Re: Parking Design Certification, 1130 Pittwater Road, Collaroy NSW

Fernway Engineering has been engaged by the Applicant to certify the proposed parking arrangements associated with the development application at the above address. This letter refers to the plans prepared by MAP Architects, overlaid in **Attachment A**, and the following regulatory design instruments:

TITLE:
 Swept Path Analysis: B85

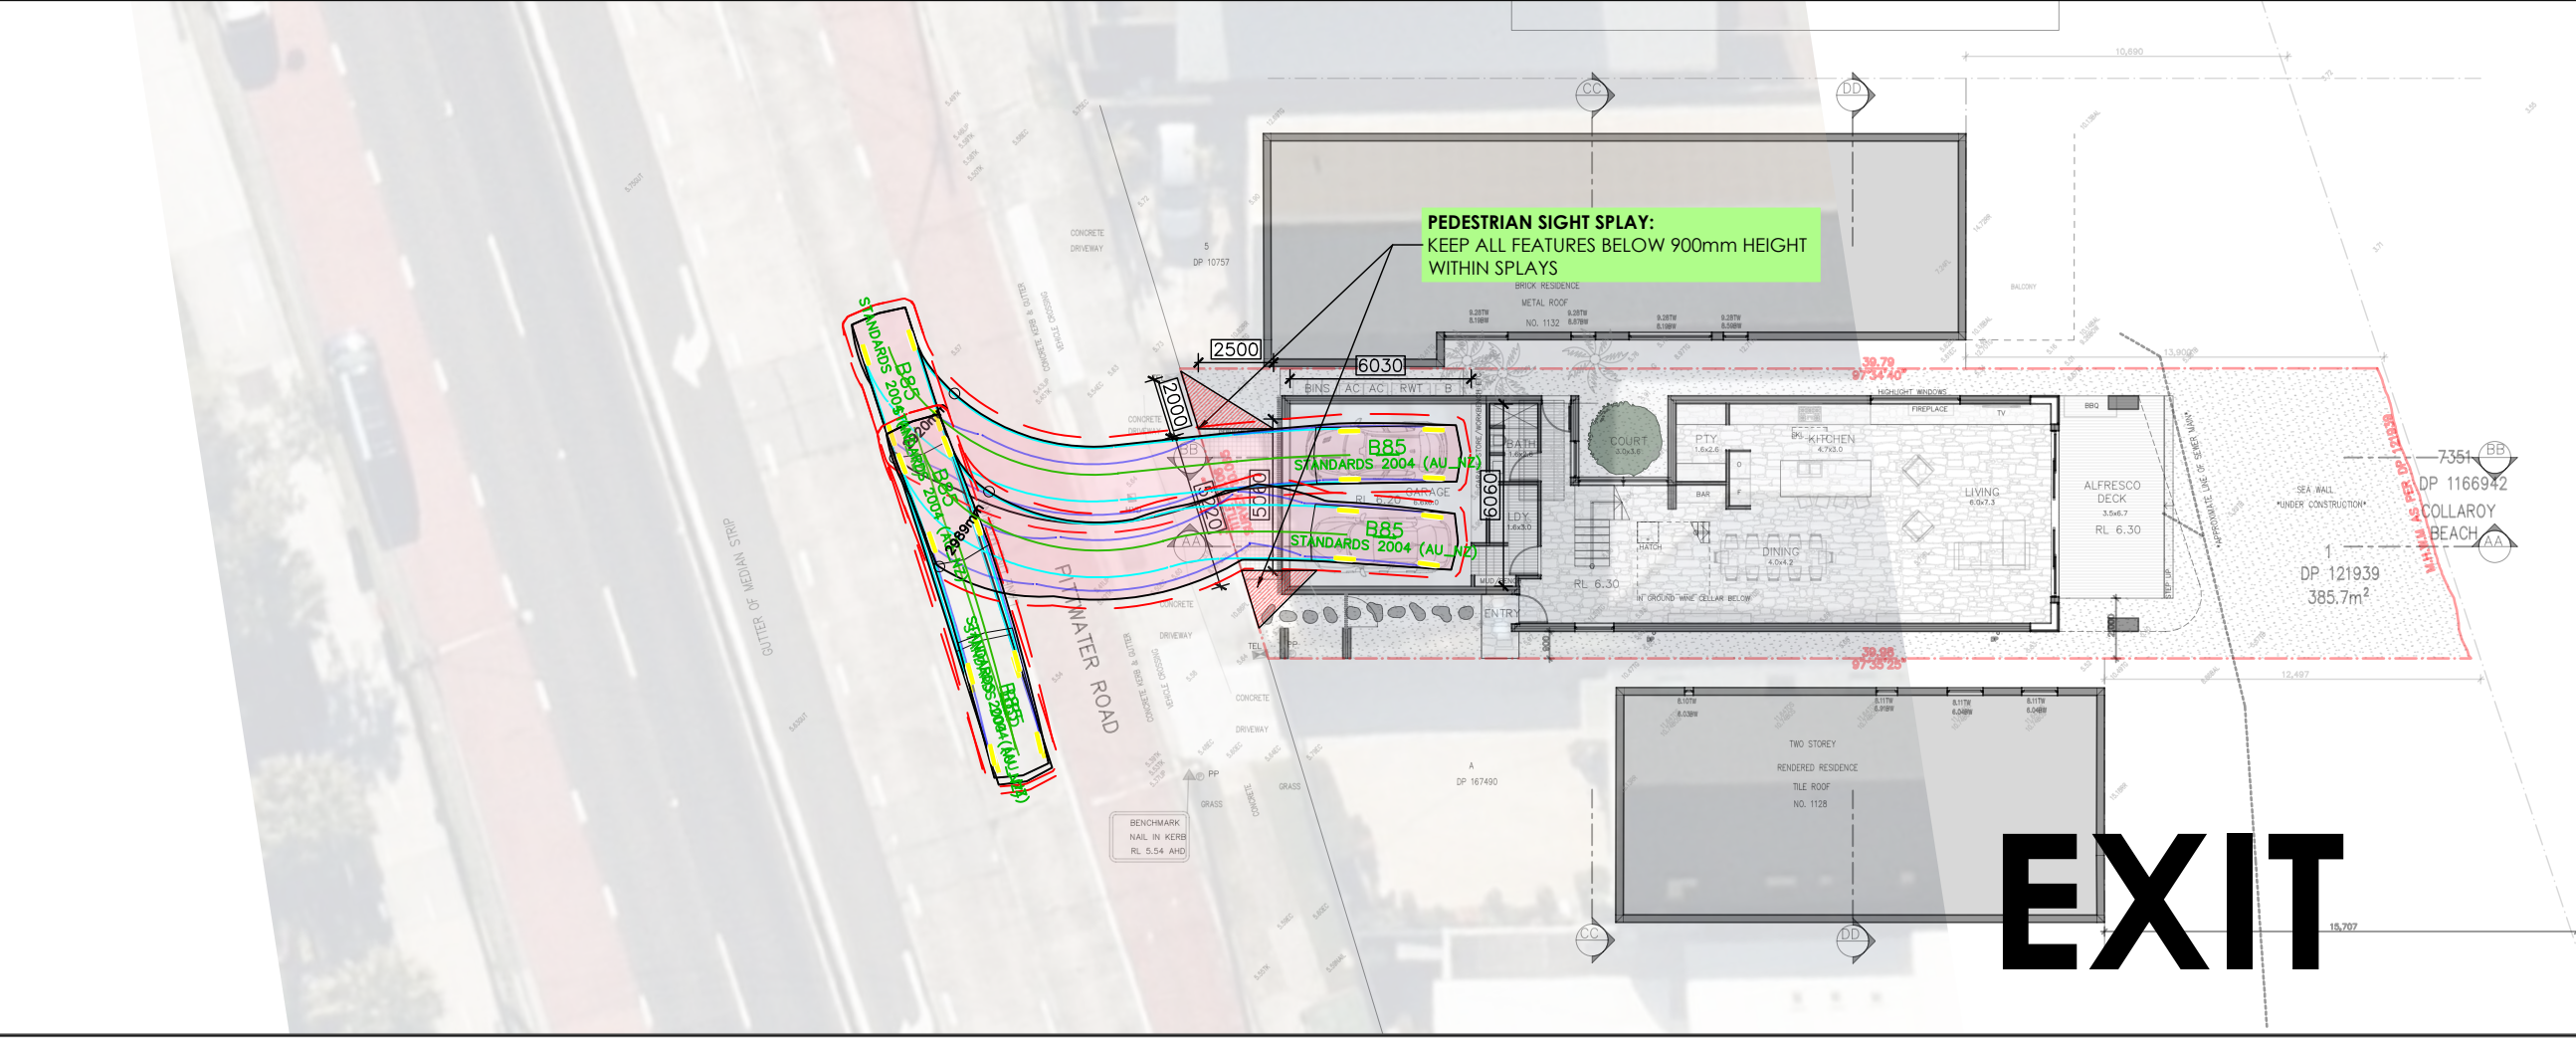
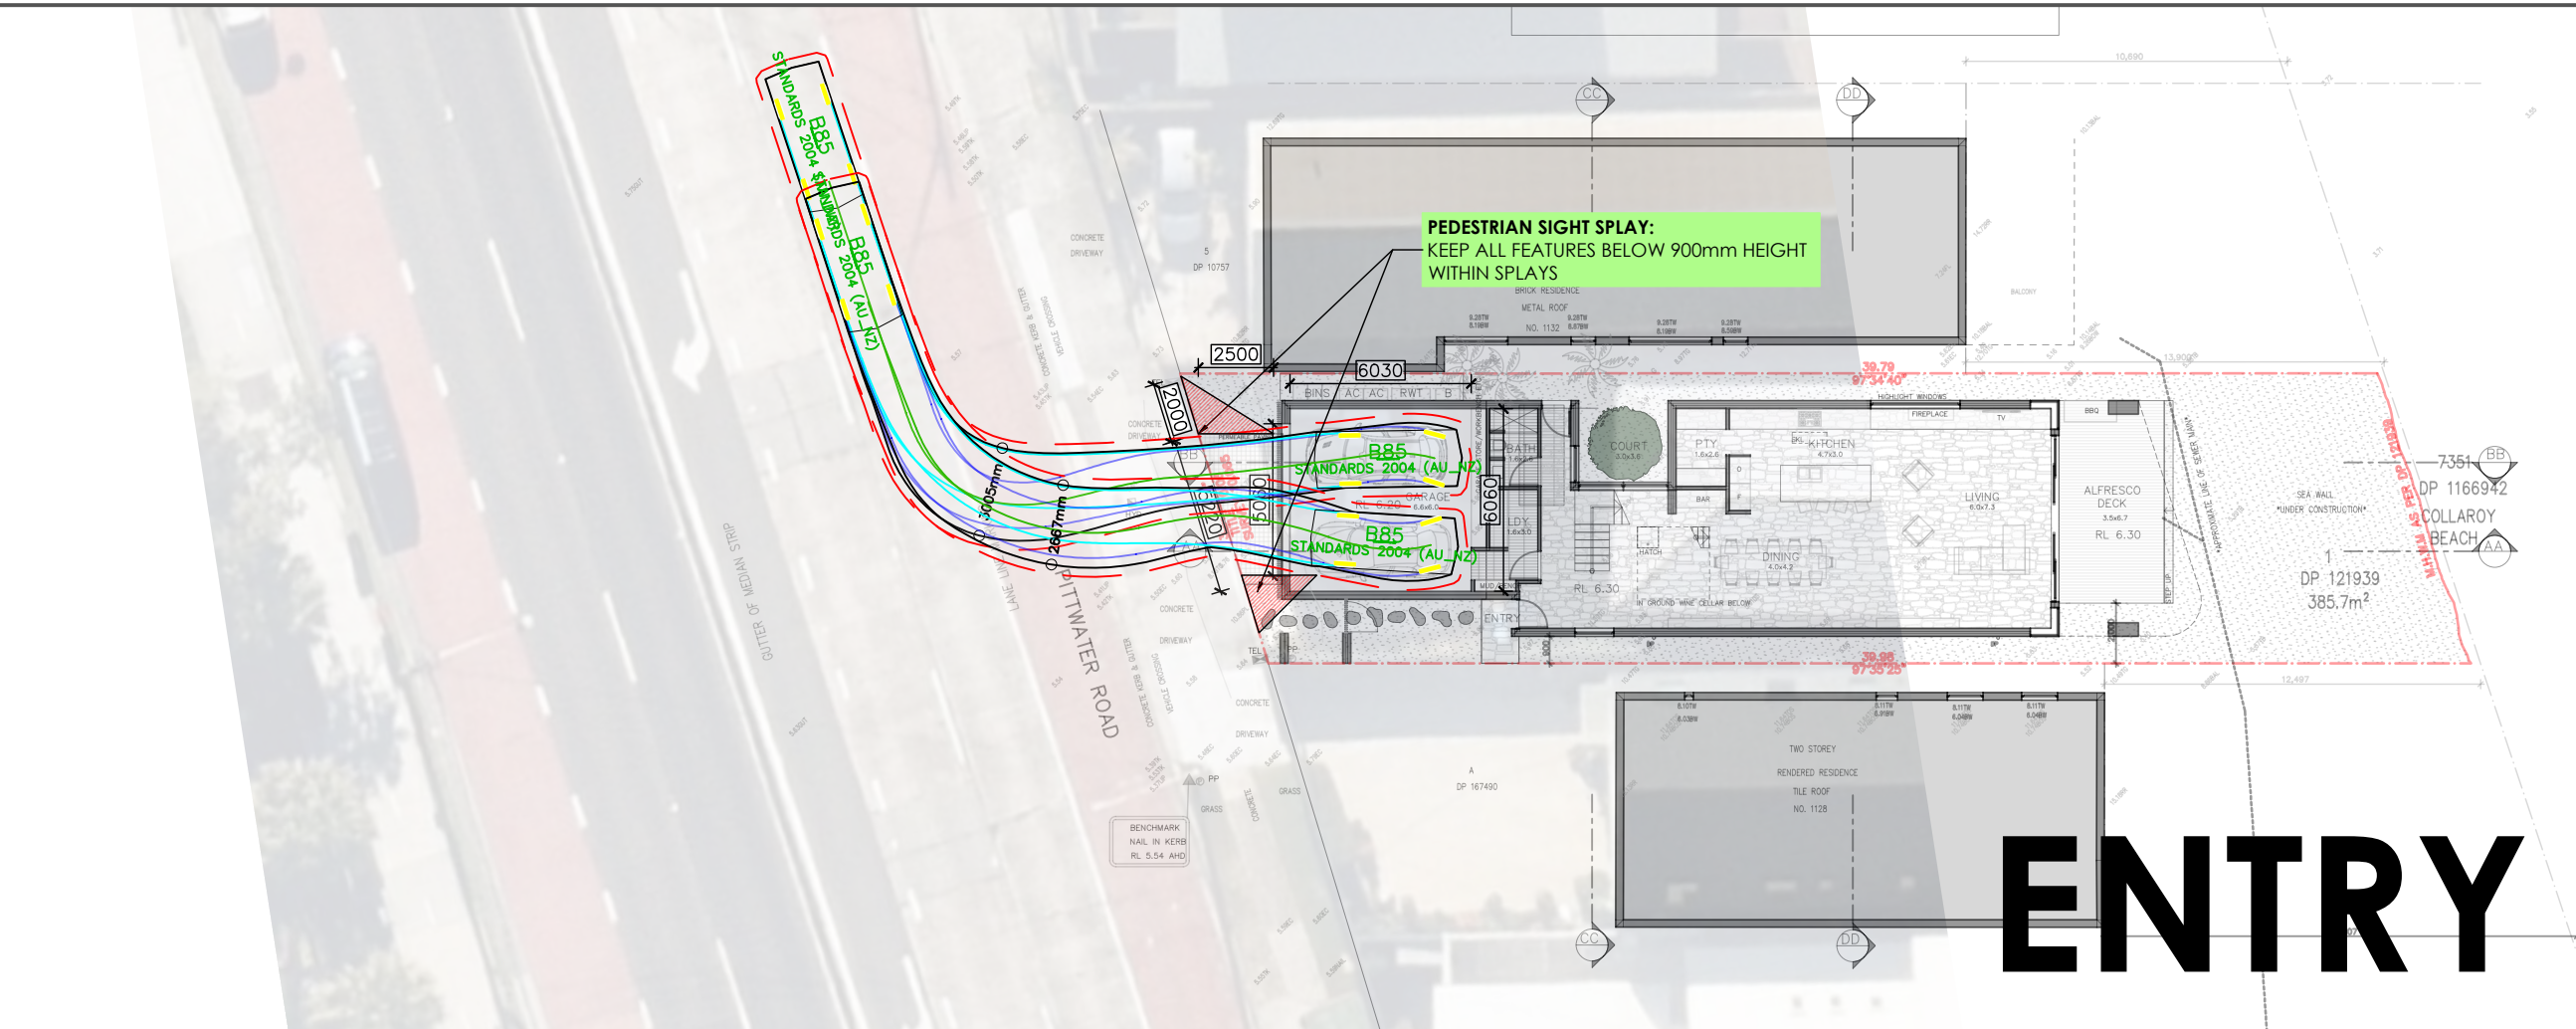
The swept path analysis was undertaken using the AutoTURN program, in accordance with the methods of Appendix B of AS2890.1:2004. The analysis concluded that:

- The design vehicle (B85) can enter and exit each parking space in a standard 3-point manoeuvre. A 300mm clearance is maintained for all objects.
- As is standard for domestic dwellings, a reverse manoeuvre is required within the public roadway.

Attachment A shows the results of the swept path tests obtained. The **Black** colour of the swept paths indicates the vehicle body envelope, while the **blue** lines indicate the wheel path and the **Red** lines indicate the 300mm clearance envelope of vehicles).

TITLE:
Ground Clearance Analysis: B99

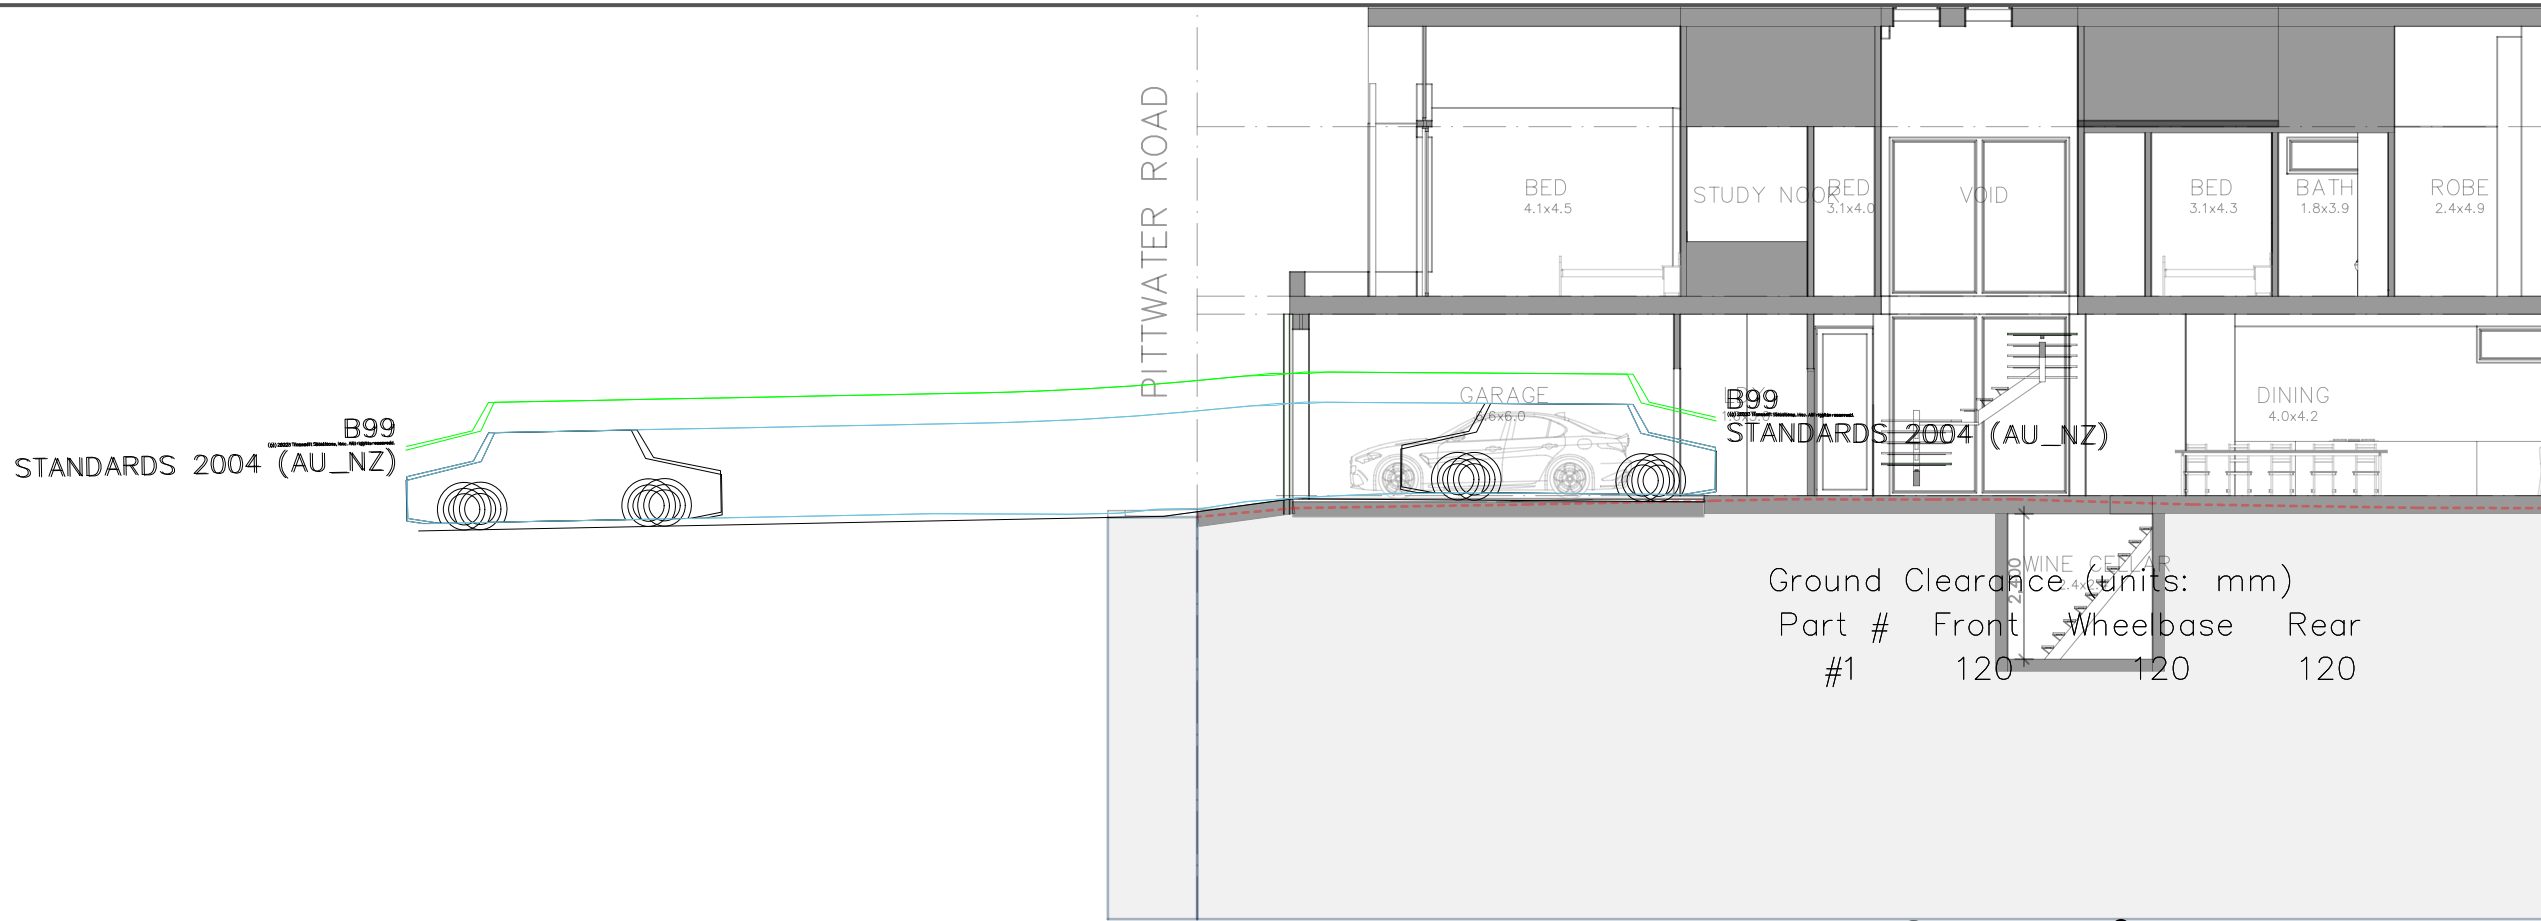
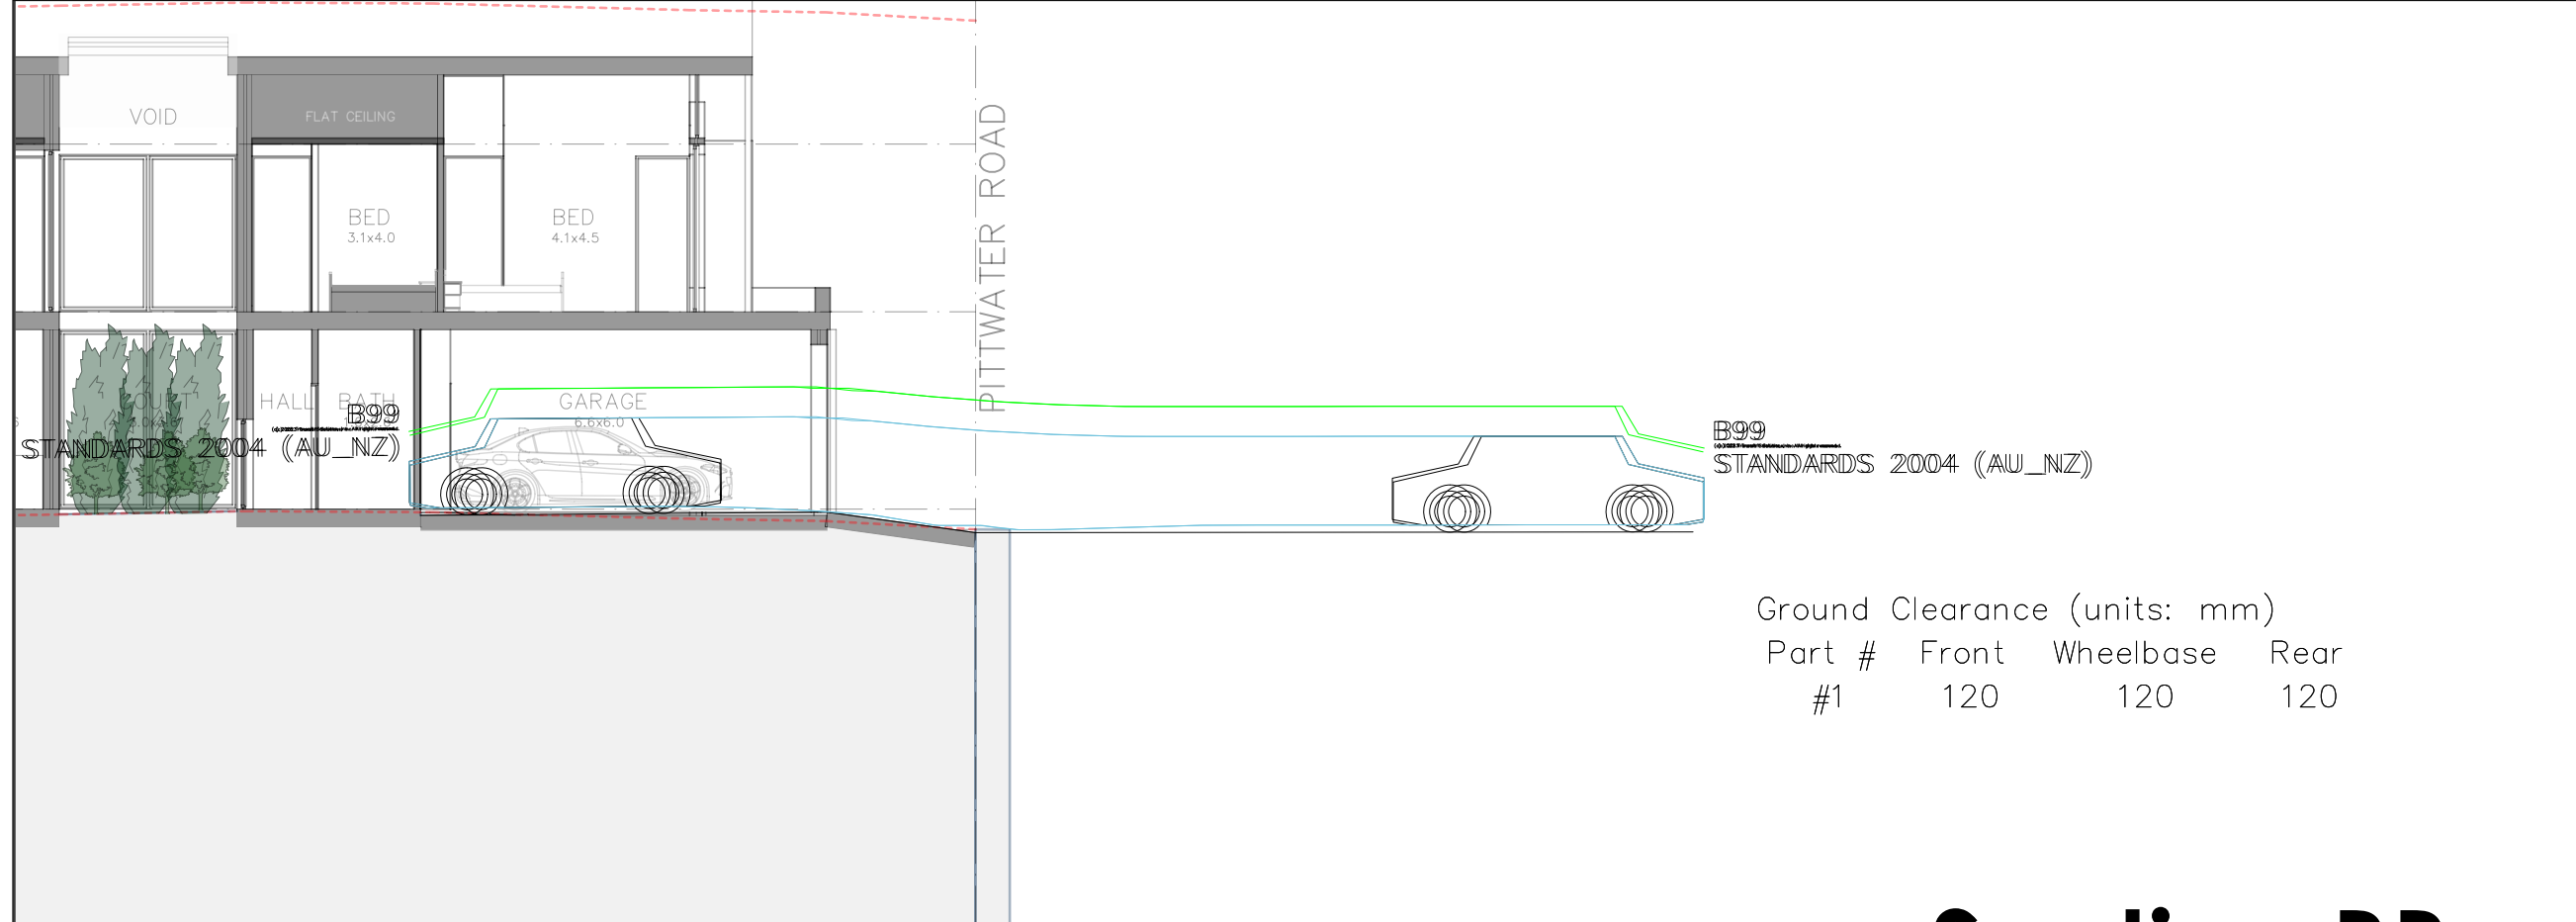
To ensure against vehicle scraping along the proposed driveway profile, ground clearance testing has been undertaken using AutoTURN software (the industry standard vehicle swept path assessment software). The 99th percentile vehicle (B99 vehicle) was used to simulate ground clearances in accordance with AS2890 ground clearance testing methodology. Testing was undertaken along each proposed driveway (Sections EE and FF).

The ground clearance assessment determined that:

- A B99 vehicle has no ground-scraping conflicts when entering or exiting the property via the proposed driveway.
